INFORMATION REPORT

1979-B7 280ZX AND 300ZX SHIFT INTERLOCK SYSTEM OWNER NOTIFICATION

Campaign Identification No.: 87SIS

VOLUNTARY RECALL CAMPAIGN, 1979-87 280ZX and 300ZX SHIFT INTERLOCK SYSTEM

FIGURE 1

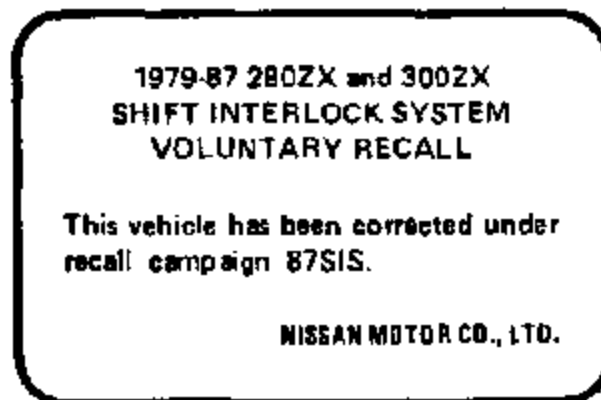
1. It is the dealer's responsibility to install a Shift Interlock System on each vehicle falling within the affected VIN range of this campaign which for any reason enters the service department. This includes vehicles purchased from private parties or presented by transient (tourist) owners and vehicles on dealer used car sales lots.
2. All owners of 1979-87 models within the affected VIN range will be notified on or after July 6, 1987.
3. The dealer must install a label under the hood (Figure 1), next to the Existing Emission Control Information label, when the correction has been completed.

Sealant coated screw for bolting down shift control assembly.

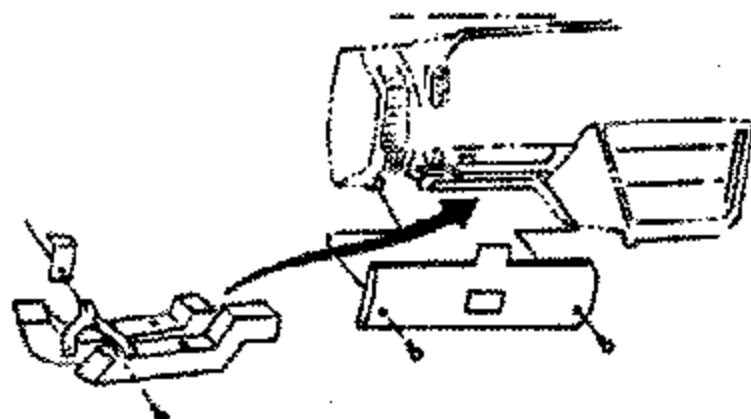
Install the new shift control assembly back into the vehicle. Be sure the shift indicator lamp harness is routed properly on the under side of the indicator assembly. Place the shift rod into the shift lever and install the nut, but do not tighten. The rod must be adjusted from beneath the vehicle. Use the screws with sealant coated threads from the kit to bolt the shift control assembly back in place.

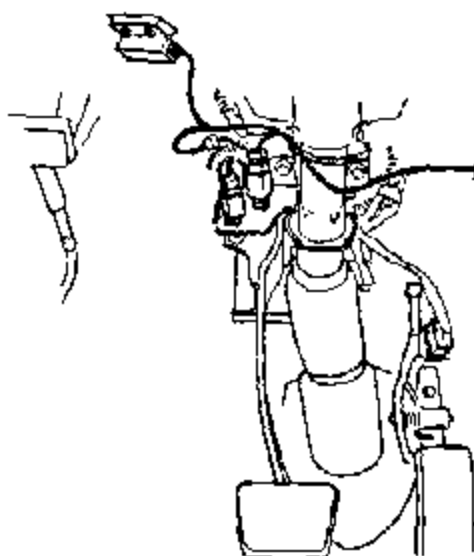
16. Install the A/T control harness as shown in the following illustration. Plug the upper end connector into the controller. Plug one connector into the brake switch and the other into the brake harness connector. Route the A/T control harness down the steering column and install a tie wrap. Re-install the side and foot air ducts.

From the steering column, the harness should be routed across the side and foot ducts. Install another tie wrap as shown.

Bring the harness back along the driver's side of the transmission tunnel and tape it down firmly with the one-sided tape strips supplied in the kit.

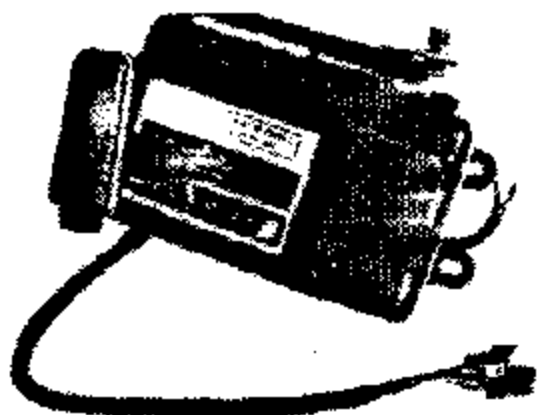
7. Use the adhesive backed metal clip to secure the shift indicator lamp wires to the side of the gear indicator as shown in the following photo. The idea is to make sure the wires are out of the way of the solenoid or mechanism in the control lever assembly.

280ZX PARK/BRAKE INTERLOCK HARNESS

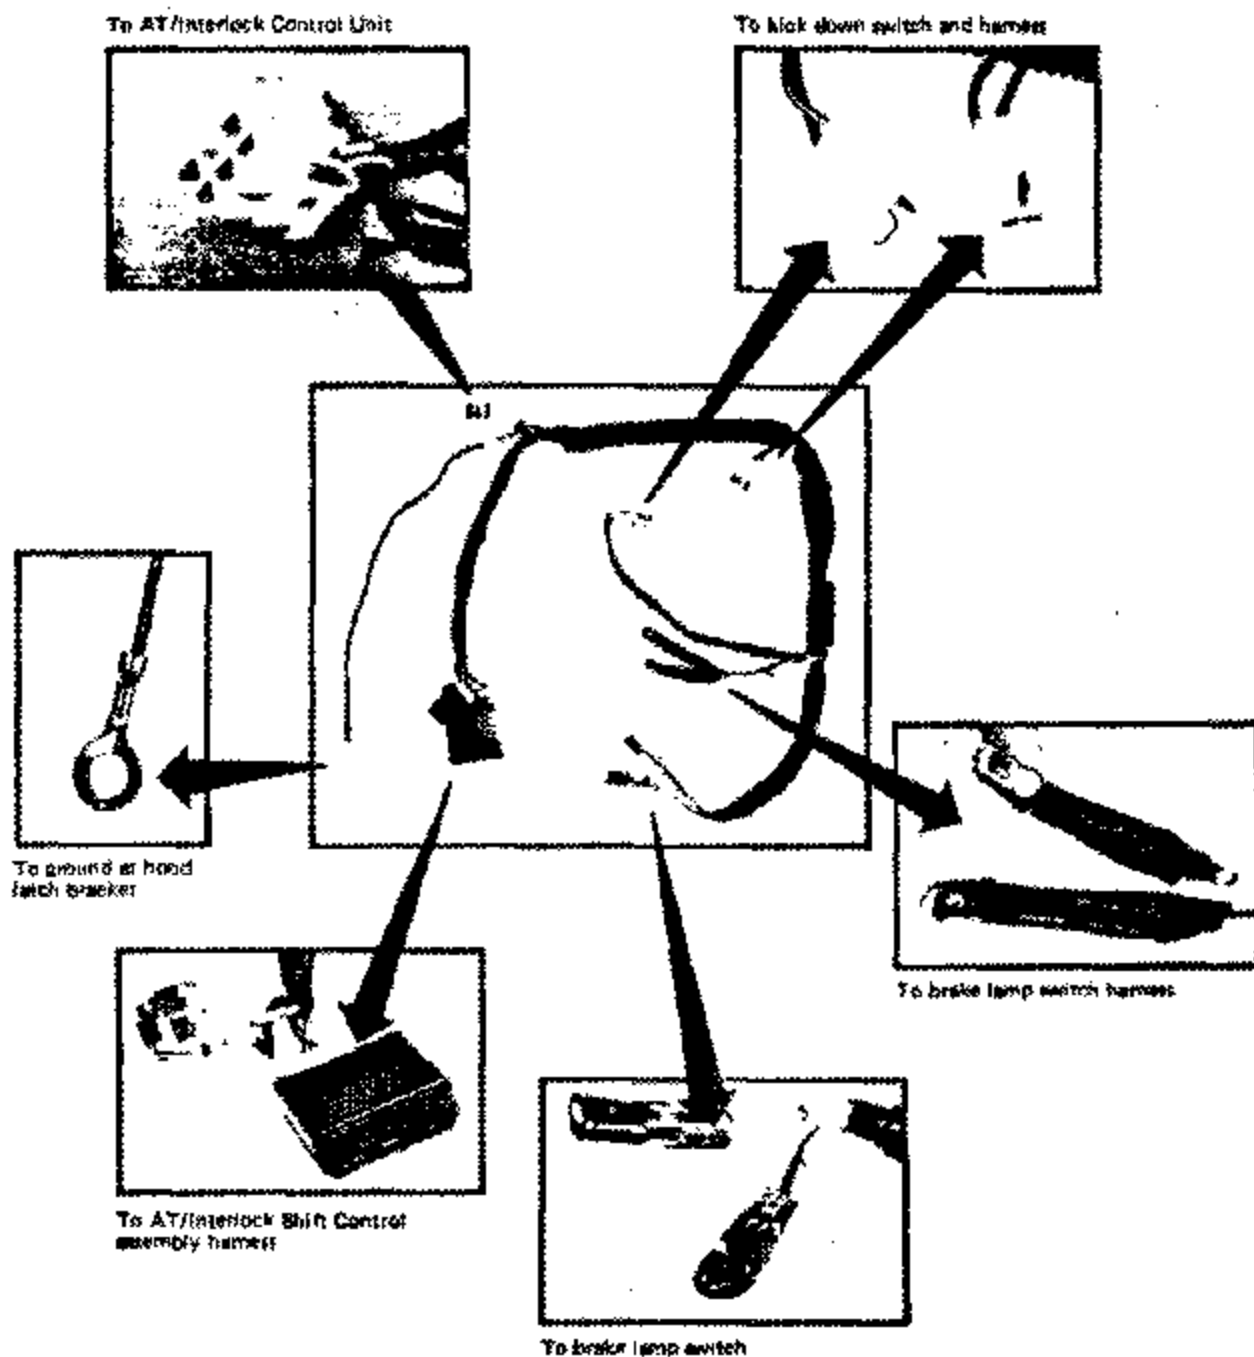
14. Install the A/T control harness as described in the following illustration.

The eyelet goes to ground at the mount bolt for the hood latch. The six pin connector will plug into the interlock control unit. The two pin connectors go into the kick down switch and its harness at the top of the throttle pedal. The single spade connectors go into the brake light switch and its harness. The last two connectors plug into the interlock harness that comes from the shift control assembly.
